APPROVAL <i>slw</i>	REQUEST FOR COUNCIL ACTION	MEETING DATE 10/17/17
REPORTS & RECOMMENDATIONS	RESOLUTION IMPOSING CONDITIONS AND RESTRICTIONS FOR THE APPROVAL OF A SPECIAL USE FOR AN AUTO PARTS RETAIL STORE UPON PROPERTY LOCATED AT 7251 SOUTH 27TH STREET (O'REILLY AUTOMOTIVE STORES, INC., APPLICANT)	ITEM NUMBER <i>6.5.</i>

**CITY OF FRANKLIN****REPORT TO THE PLAN COMMISSION**

Project Name:	O'Reilly Auto Parts Special Use
Project Address:	7251 South 27 th Street
Applicant:	Patrick Blee, Architect, PLLC
Property Owner:	O'Reilly Automotive Stores, Inc.
Current Zoning:	B-4 South 27 th Street Mixed Use Commercial District
2025 Comprehensive Plan	Mixed Use
Use of Surrounding Properties:	St. James Catholic Congregation and School to the north, Park Motel and Little Cancun restaurant to the south, City of Oak Creek (residential) to the east and single-family residential to the west
Applicant Action Requested:	Recommendation of approval for the proposed Special Use and associated Site Plan for the development of an O'Reilly Auto Parts store.

SHEET TITLE:
EXTERIOR ELEVATIONS

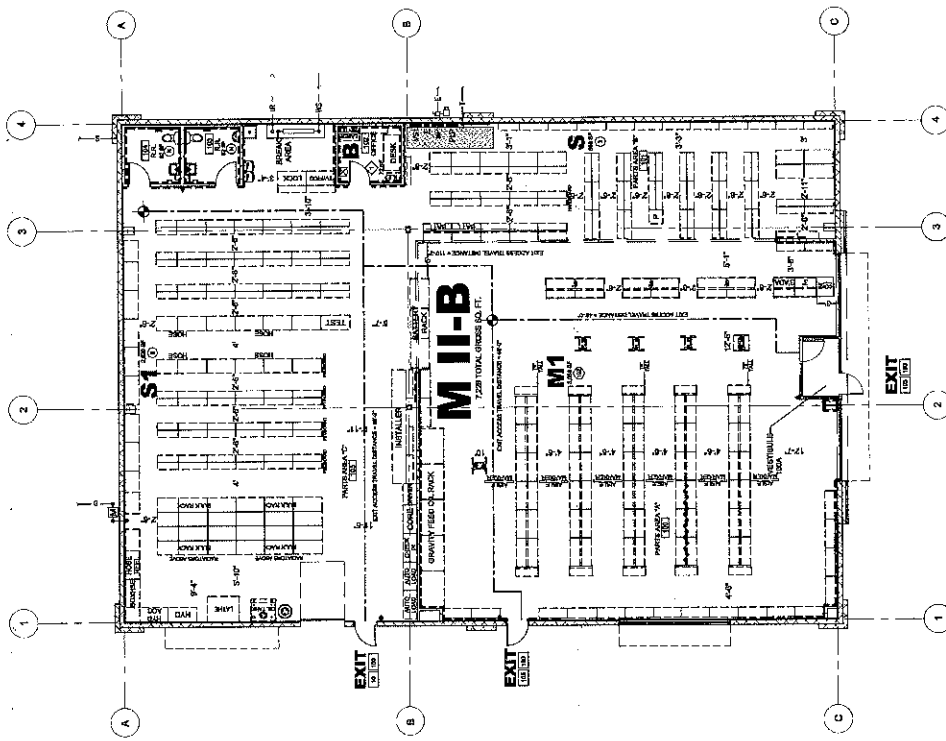
Staff's Recommendation/Suggestion: Staff recommends that the applicant shall submit revised elevations, for Department of City Development review and approval, that provides additional architectural enhancements to better comply with the architectural standards as detailed within the South 27th Street Design Overlay District standards, prior to issuance of a Building Permit. Specifically, staff recommends consideration of providing more variation/articulation to the building, such as: varying building setbacks; more/larger façade protrusions and/or recesses; additional variations in building and/or parapet height; additional building materials (stucco, wood, stone, terra-cotta) or patterns, etc.

Staff's Recommendation/Suggestion: Staff recommends that the applicant shall submit revised elevations, for Department of City Development review and approval, that provides additional roofline variation, particularly along the side and rear elevations as well as a brick coursing element, prior to issuance of a Building Permit.

13. Revised elevations shall be submitted for Department of City Development review and approval that provides additional architectural enhancements to better comply with the architectural standards as detailed within the South 27th Street Design Overlay District standards, prior to the issuance of a Building Permit. Specifically, the elevations shall provide more variation/articulation to the building, such as: varying building setbacks; more/larger façade protrusions and/or recesses; additional variations in building and/or parapet height; additional building materials (stucco, wood, stone, terra-cotta) or patterns, etc.

14. Revised elevations shall be submitted for Department of City Development review and approval that provides additional roofline variation, particularly along the side and rear elevations as well as a brick coursing element, prior to the issuance of a Building Permit.

1 MASONRY SCREEN FENCE REFUSE ENCLOSURE PLAN
SCALE: 3/4" = 1'-0"

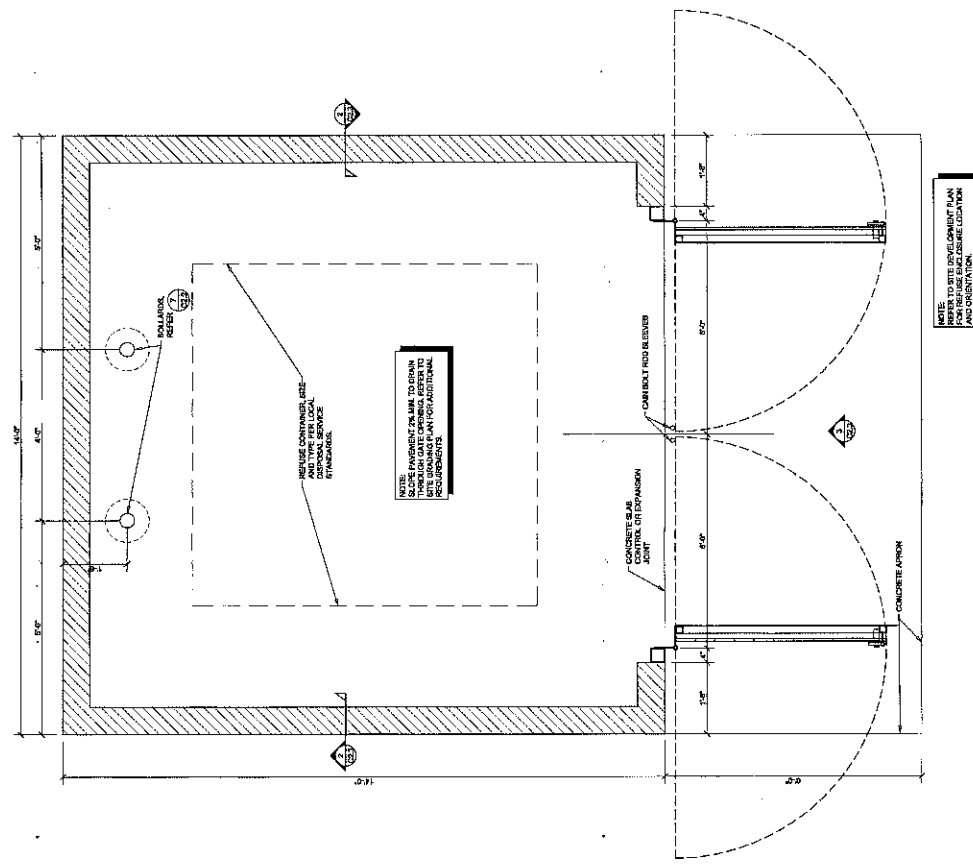
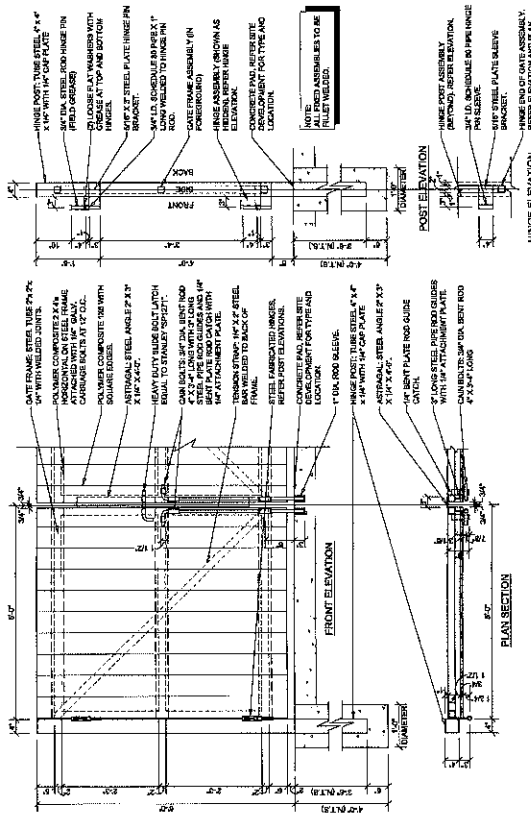
8. Please provide dumpster enclosure details. Staff assumes this may be on Sheet C2.2 or C2.3; however, those plan sheets were not provided. Staff recommends that the dumpster enclosure materials match that of the principal building. *See enclosed sheet C2.3.*
9. On Sheet C2.1, please include additional site data, such as square footage of proposed impervious surface, greenspace and Landscape Surface Ratio (see definitions below). *See enclosed sheet C2.1.*

Li.1	PCAMM 1" = 207.5
------	------------------

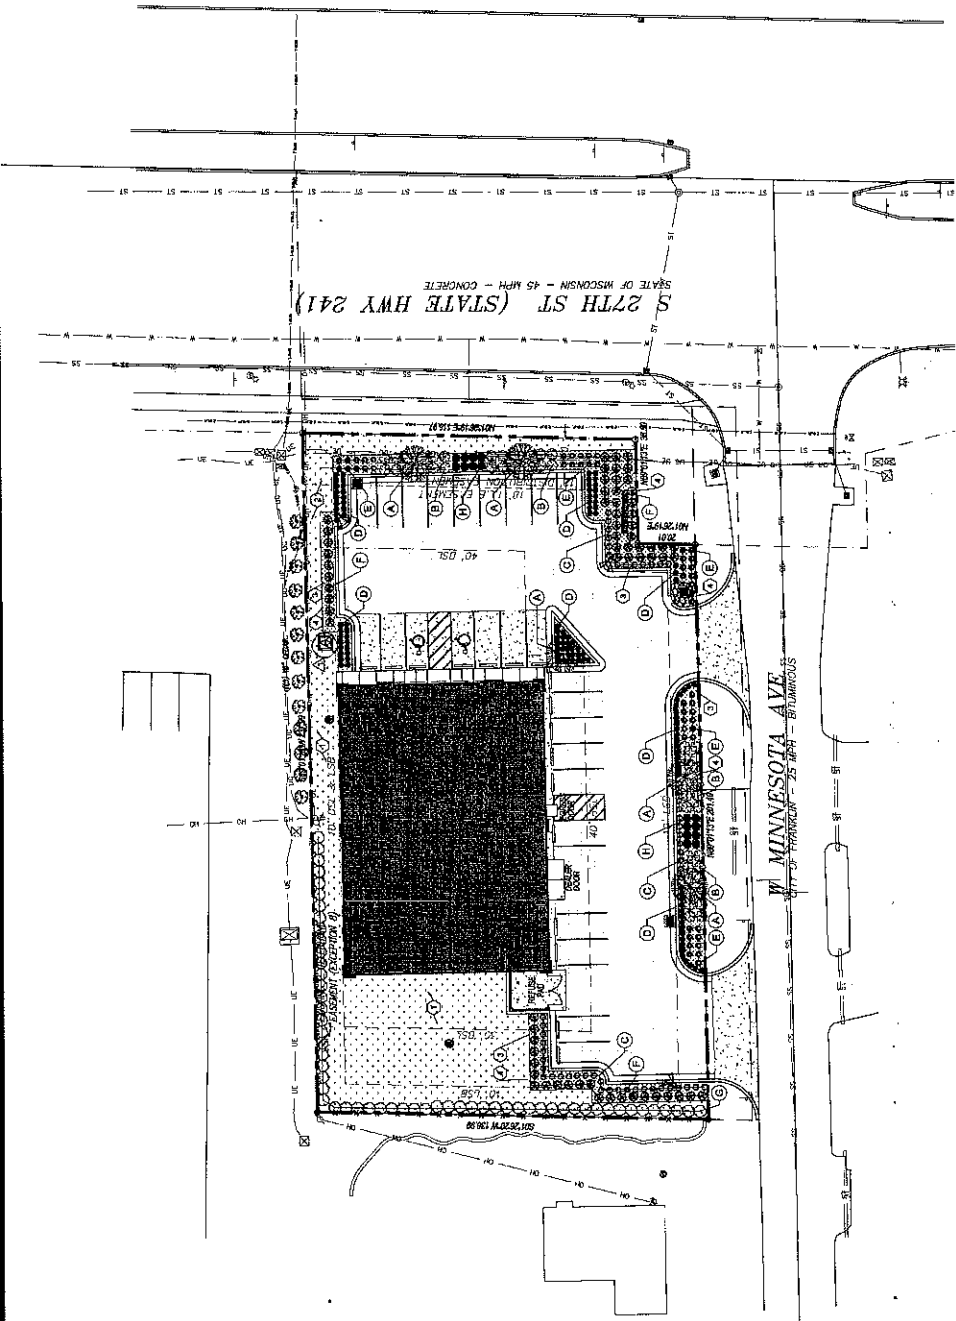
- A greater variety of plantings shall be provided along the west and north property line to serve as the bufferyard, opposed to consisting of entirely Emerald Green Arborvitaes. Furthermore, the plantings shall be staggered, opposed to in a single row.

Staff's Recommendation/Suggestion: Staff recommends that the applicant shall submit a revised Landscape Plan, for Department of City Development review and approval, that includes foundation plantings or planters along the south and east sides of the building, prior to issuance of a Building Permit.

- c. A greater variety of plantings shall be provided along the west and north property line to serve as the bufferyard, opposed to consisting of entirely Emerald Green Arborvitaes. Furthermore, the plantings shall be staggered, opposed to in a single row.

12. A revised Landscape Plan shall be submitted for Department of City Development review and approval that includes foundation plantings or planters along the south and east sides of the building, prior to the issuance of a Building Permit.
